CITY OF CARMEL-BY-THE-SEA HISTORIC RESOURCES BOARD

REGULAR MEETING Monday, June 19, 2023

SUBMITTED BY: Evan Kort, Associate Planner

SUBJECT: **DS 22-396 (Ramos):** Consideration of a Determination of Consistency with the Secretary of the Interior's Standards for Design Study application, DS 22-396 (Ramos), for site additions, alterations, and site modifications, including a 138-square-foot addition to the rear and a new entry at the north elevation, a 398-square-foot basement expansion, creation of a window well at the front elevation, window relocation and modifications, and a new 231-square-foot detached garage located in the front to the historic "Rockwell House" located on the northeast corner of 12th and San Antonio Avenues in the Single-Family Residential (R-1) Zoning District and the Beach and Riparian Overlay District. APN 010-279-008

(E) NORTH ELEVATION
SCALE: 1/4" = 1'-0"

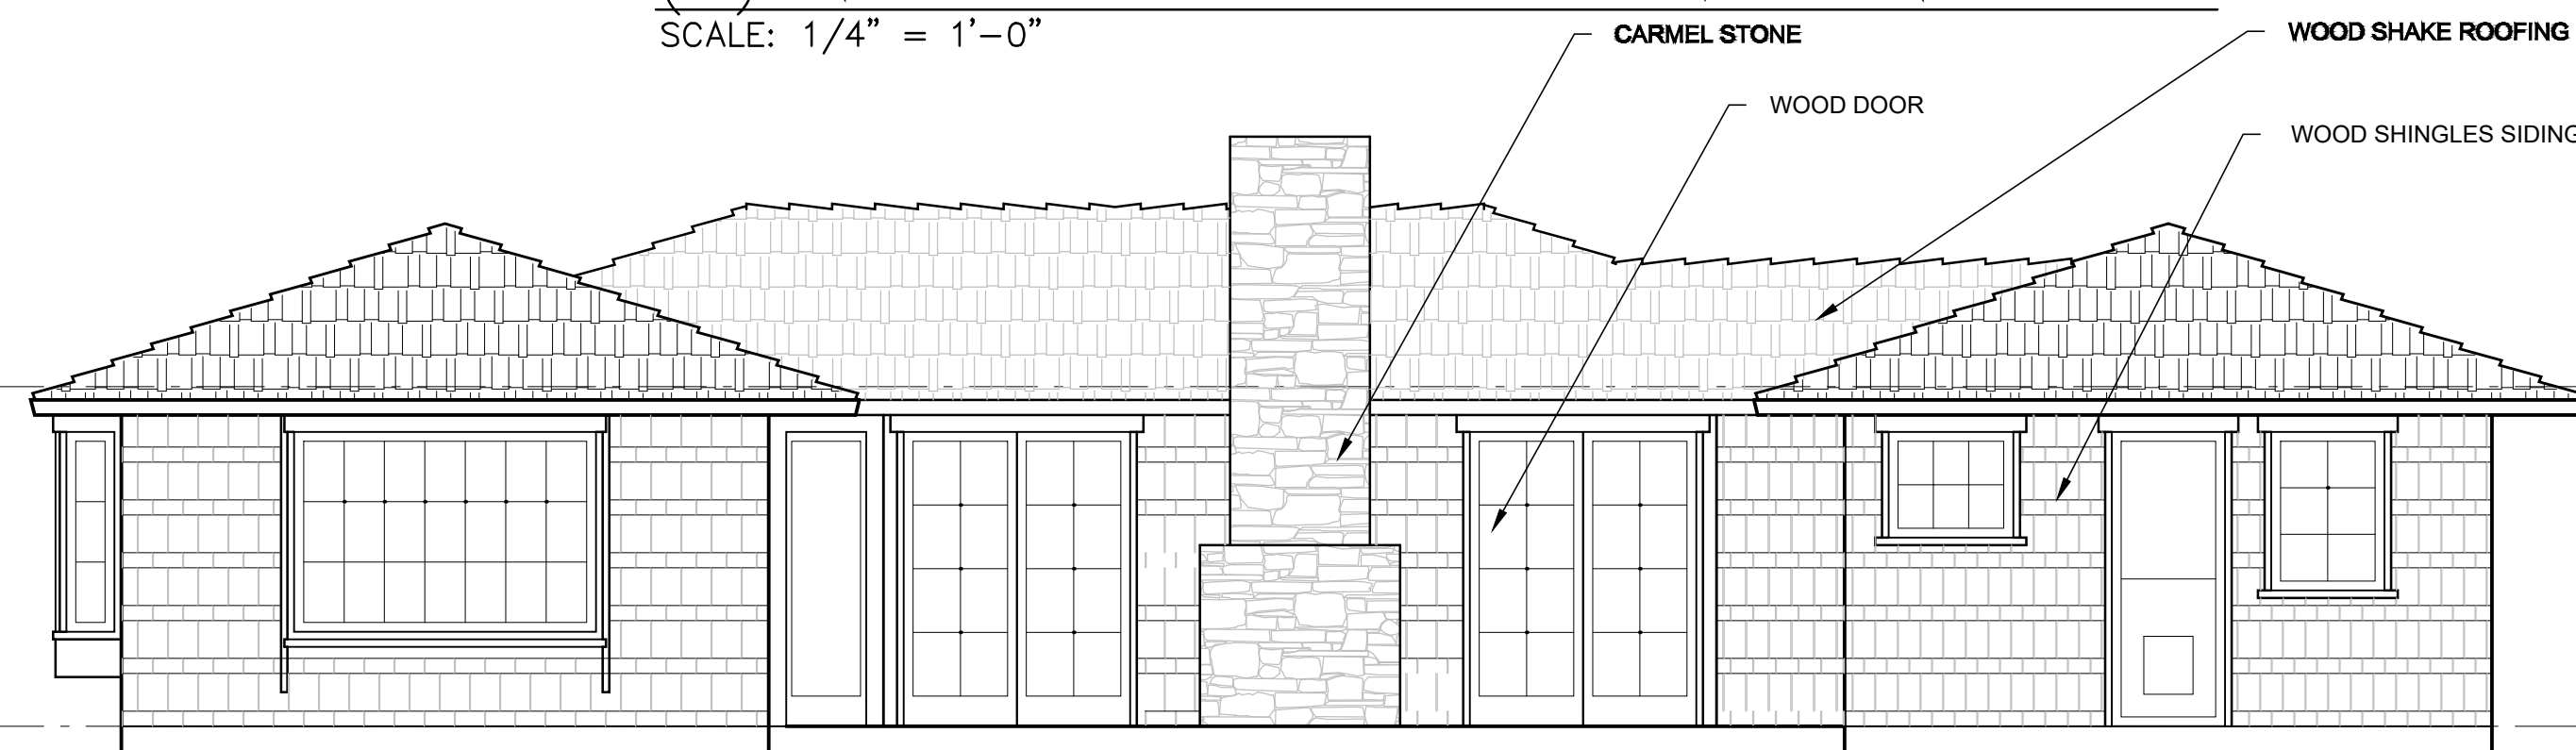
West (Front) elevation: The wood shingle siding, wood shake roofing, and most of the windows on the main level will be retained. The two small windows at the lower level will be removed. The new windows at the lower level will be screened by a window well, and a new French door will replace the garage door, which is a non-character-defining feature. However, the French door will not be visible from the street as the new detached garage will be located in front.

South (Side Street) elevation: The construction of a new entrance on the south elevation will remove one original square bay window and one non-original canted bay window. However, a relocated window will replace the non-original canted bay window. According to Meg Clovis, qualified professional, the removal of the original square bay window is not ideal, but will not affect the integrity as a whole.

East & North elevation (Rear & Side): The rear (east) addition will remove an original Dutch door and two non-original windows, and on the side (north) will remove two windows. The current kitchen area was expanded in 1950, and removing these windows does not affect the house's integrity since they are not original. However, the original Dutch door was moved to the back during the 1950 floor area expansion. The Dutch door is considered a character-defining feature and should be preserved. The applicant has proposed to reuse the Dutch door as an exterior egress door on the lower level adjacent to the proposed garage location.

2. New siding & roof materials shall be slightly differentiated but compatible with the old siding & roof materials.
3. **South elevation** - Prior to the approval of the Design Study, the applicant shall show and provide samples that the proposed entrance shall have a different aesthetics regarding the siding, roof, and columns to differentiate it from the original house.

4. **Dutch door** - Prior to the approval of the Design Study, the applicant shall repair the original Dutch door currently in the east elevation and reuse it, and, if repair is not possible, provide photos and written documents showing that the original Dutch door cannot be preserved and provide material, dimensions, and a color sample of the original prior to in-kind replacement.
